Licence Number L6882/1997/13

Licence Holder Shire of Esperance

Premises Wylie Bay Sanitary Landfill Site
Wylie Bay Road

Date of Amendment 03/08/2018

Figure 9: Proposed landfill extension area (also refer to Figure 3 for locations of existing landfill phases 1 - 3).

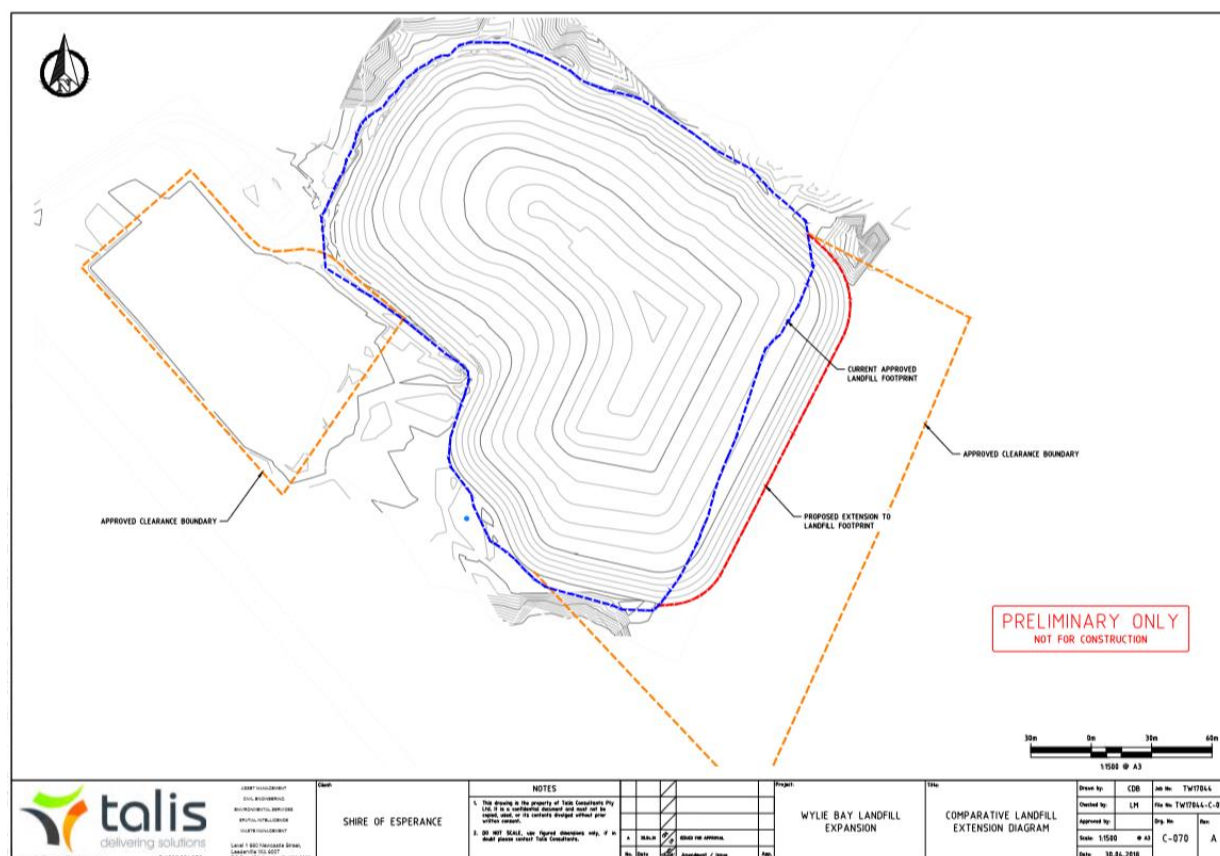
The Licence Holder is proposing to extend the footprint of the landfill by an additional 18,410 square metres. Figure 9 depicts the current footprint in blue, and the proposed additional landfill area in red.

The additional footprint is requested to accommodate an additional three years of operational life, equating to an additional 150,000 cubic metres in total, based on the maximum licence throughput of 50,000 cubic metres per year.

Premises map

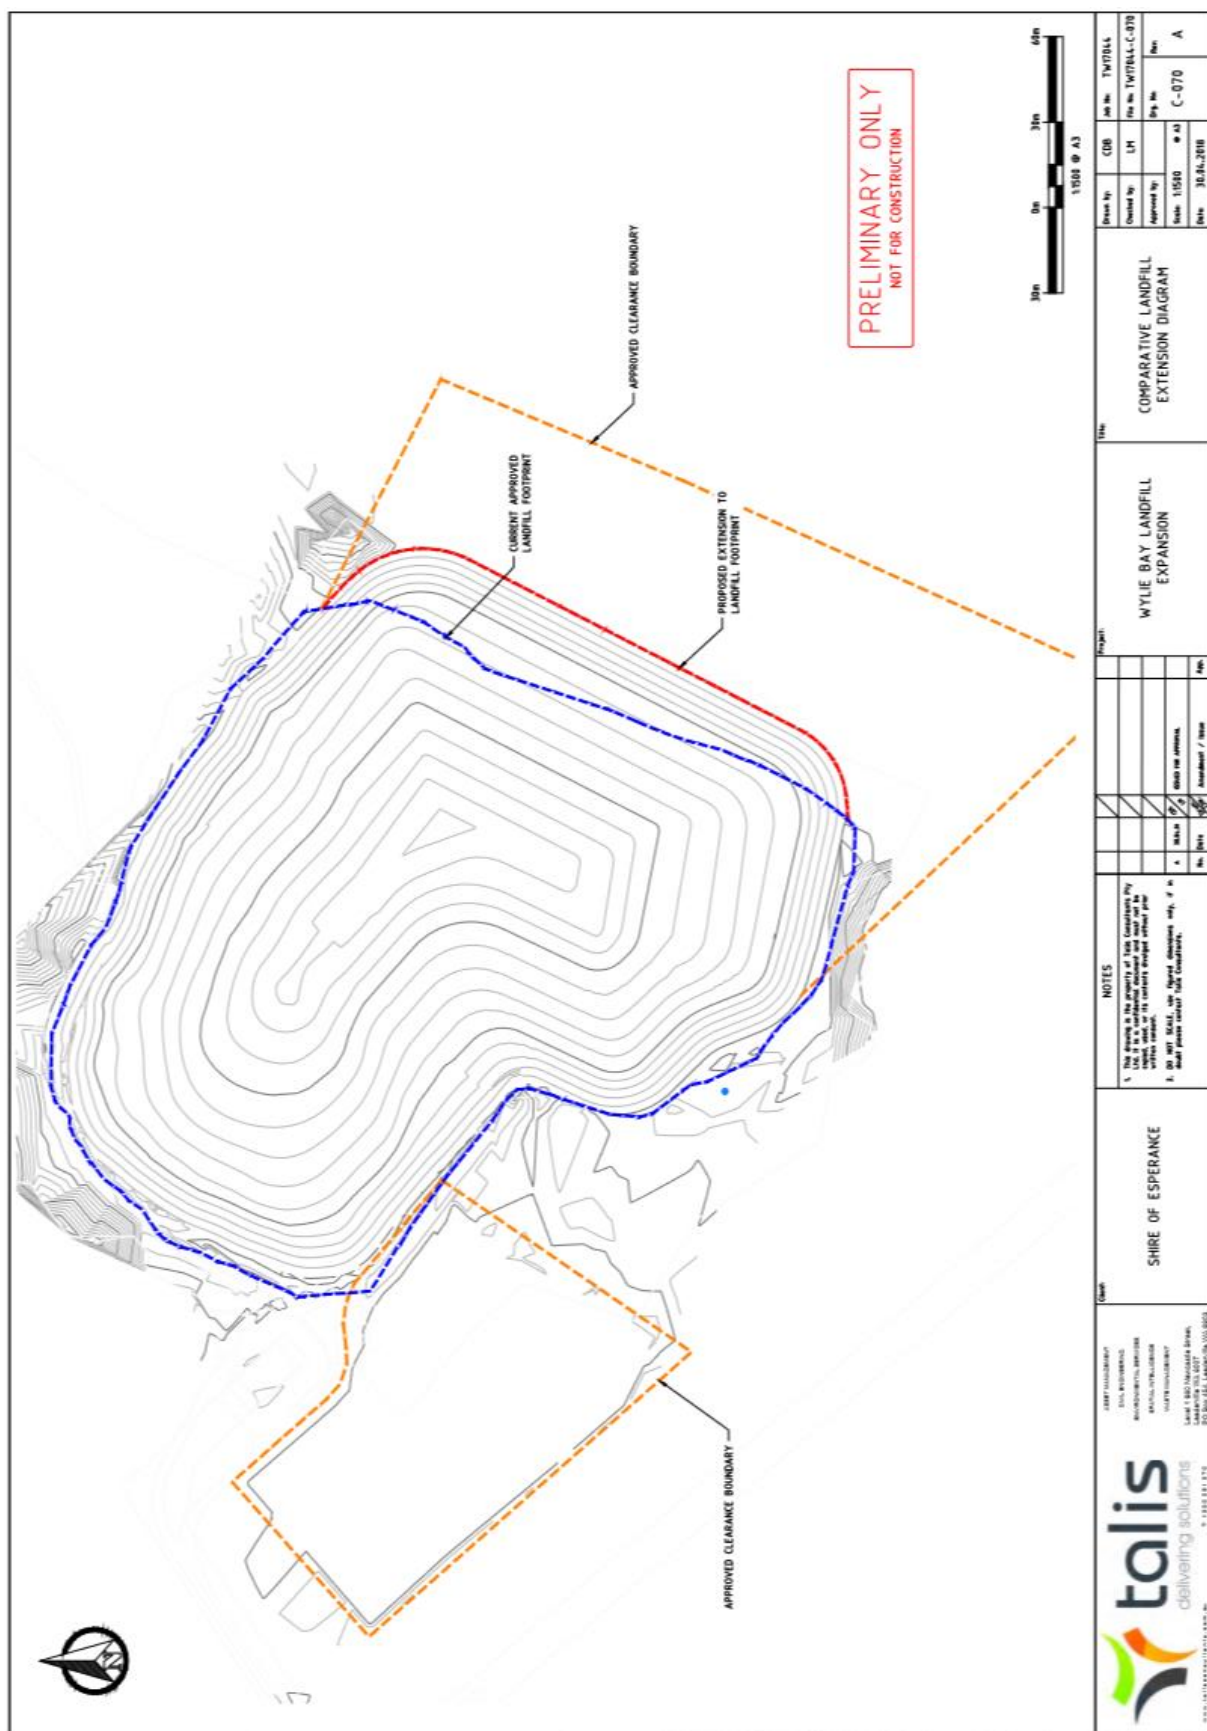
9. The Licence is amended by the insertion of the following maps in Schedule 1:
